Wrexham Solar Development

Flood Consequence Assessment

REPORT REF: 258/FCA/v2

May 2021

Figure 4-6: Post-development flood depths (1%CC with blockage)

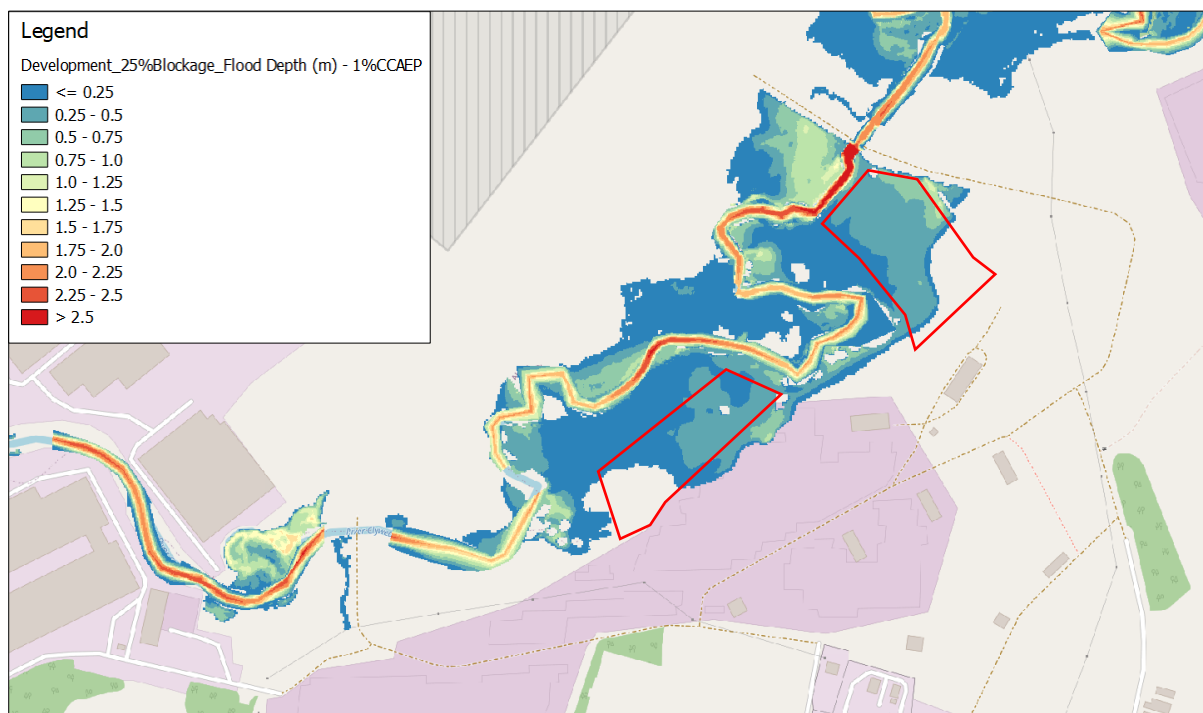
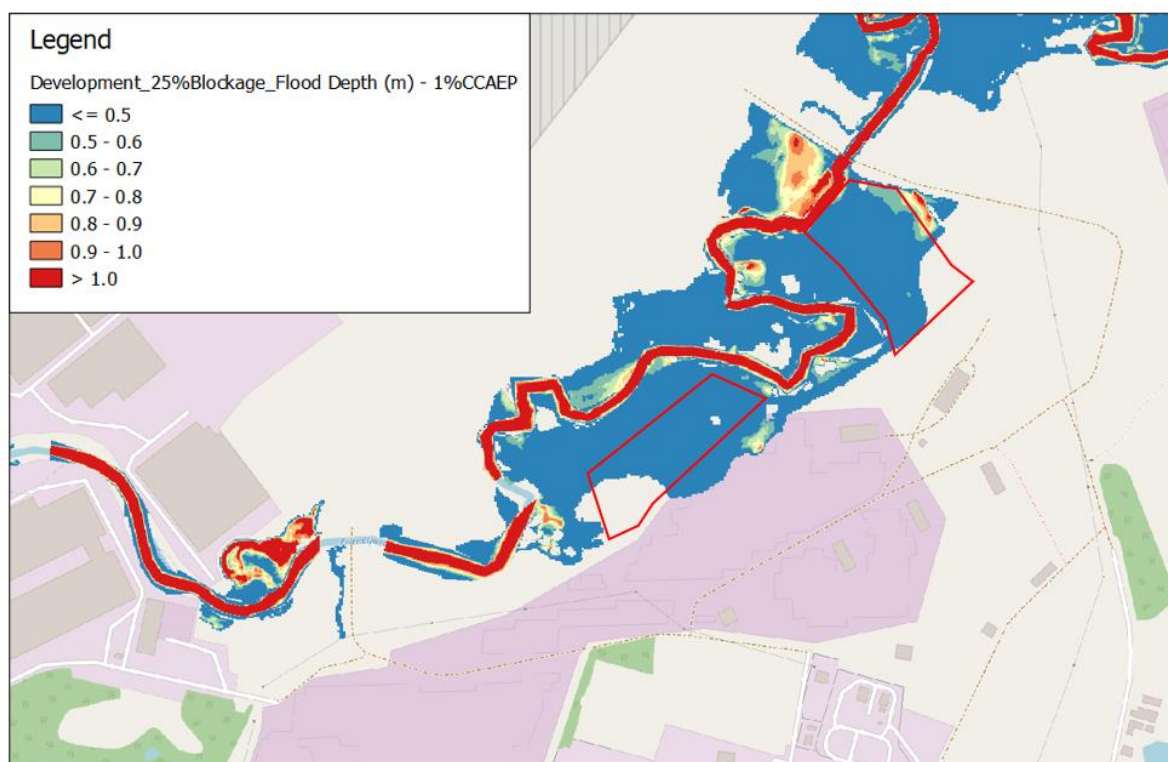
PV1	We note that the draft Flood Map for Planning has been included within the FCA. As this has yet to be published, the map should not be referred to in the FCA, and it does not hold any weight for the purposes of a planning application. The Development Advice Map (DAM) remains the key flood map for planning purposes.	<i>Figure 2-7, Figure 3-2 and Figure 3-6 have been replaced with the appropriate maps with links shown beneath each map.</i>
PV2	We note that the FCA refers to the proposal being classified as 'highly vulnerable development'. In accordance with the Caldicot Levels appeal (APP/G6935/A/16/3150137) we consider the proposal to be less vulnerable development, although the Local Planning Authority should be consulted to provide clarification on this.	<i>Text amended in Section 2.3 with reference to the captioned case.</i>
PV3	The hydraulic modelling has assessed a range of events for the site. The key event for the proposal is the 1% Annual Exceedance Probability (AEP) event with an allowance for climate change. The flood levels for this event are not included within the FCA. For completeness, the report should be updated to include these. However, the FCA does include some model outputs	<i>Table of flood levels included as Table 4-4. Flood depth maps have been amended to show the maximum depths of flooding within areas of solar panels (Figure 4-6).</i>

which show the expected flood depths within the parcels of land where the new solar panels would be located. The outputs show that the maximum flood depth for the parcels is up to 0.5 m, although the eastern parcel is on the border of the 0.5 to 0.75 m depth band.	
PV4	In terms of flood mitigation, the FCA recommends that the base of any panels are located at least 0.8 m above ground levels. Based on a maximum flood depth of 0.5 m, this approach would ensure that all the solar panel bases would be set at least 0.3 m above the predicted flood level. All electrical infrastructure (aside from the panels and cabling) will be located outside of the modelled flood extent. However, this assessment does not consider the impact of the blockage of nearby structures (the bridge immediately downstream of the site), which should be considered as part of the design event. The FCA states 'the open nature of both bridge openings does not suggest that they will be prone to blockage. If this did occur, there would likely be localised impacts upon flood levels with no practical consequence for the proposed development.' This should be quantified through examining the impact this would have on localised flood levels, particularly given the proximity of the solar panels (Field 1A) to this structure. Blockage proportions should follow the guidance in GN43: Modelling blockage and breach scenarios. It should be ensured that the solar panel bases have sufficient freeboard above the 1% AEP event with an allowance for climate change and blockage.	<i>Blockage has now been included in the model runs with modelled flood depths shown in (Figure 4-6). Recommendations for the minimum height of panels (front edge) are made in Section 4.3.2 and which provide a minimum freeboard of 300 mm between the reference flood level and the base of the panels.</i>

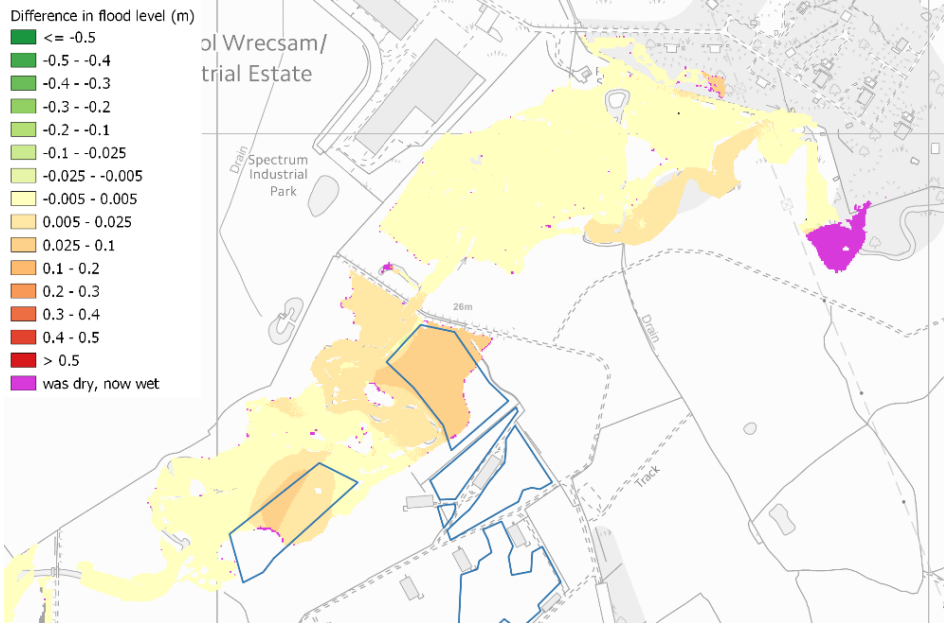
PV5	The FCA has undertaken a detailed assessment of the potential impact of the proposals on flood risk elsewhere. We appreciate the difficulties in modelling this for a solar farm development. This has been investigated through adopting an increased roughness value to account for the impact of the solar panel supports on flood flows. The analysis indicates that some increases in flood depth would be expected for the 0.1% AEP event, but these are generally within the modelling tolerance of 5 mm. However, some increase in excess of this are indicated, up to a maximum of 90 mm. The FCA states that all increases are within the red line boundary and do not impact third party land. There is no redline boundary shown on the depth difference maps; however, based on a comparison with the application documents, it appears that some of this increase is outside of the redline boundary. If all increases are within the redline boundary (or land ownership boundary) this would be considered acceptable but increases to third party land would be more of a cause for concern. We require that the FCA is updated to provide some clarification on this. If depths are increased outside of the redline boundary (or the landownership boundary) further information should be submitted to clarify how significant	<i>We have investigated the occurrence of these increases. They are spurious, since the interventions cannot lead to "downstream" increases in flood water levels. Our review has identified some errors in parameterisation. Their correction has led to a general improvement in the model, including for these spurious increases. It is this revised model (April 2021) that has been used to produce the flood extents and depths presented in this Report. There is accordingly, some inconsistency with the model version described in the Flood Model Report. The model is due to be</i>

these increases are. We note that the FCA states that no ground raising is proposed within the flood outline.  Difference in flood level (m) <= -0.5 -0.5 - -0.4 -0.4 - -0.3 -0.3 - -0.2 -0.2 - -0.1 -0.1 - -0.025 -0.025 - -0.005 -0.005 - 0.005 0.005 - 0.025 0.025 - 0.1 0.1 - 0.2 0.2 - 0.3 0.3 - 0.4 0.4 - 0.5 > 0.5 - was dry, now wet	revised further, in light of NRW comments, as part of its use on an adjacent Site for which a Flood Map Challenge will be undertaken. The Report has been amended to clarify the increases in flood levels arising from the development (Section 4.3.2).
PV6	The water level difference between the post-development and baseline model results for the 1% Annual Exceedance Probability (AEP) event with an allowance for climate change is different to that shown in the FCA report (please see attached). We would expect this issue to be clarified in the report that is submitted in support of the planning application.	Please see response to comment PV5 (above).
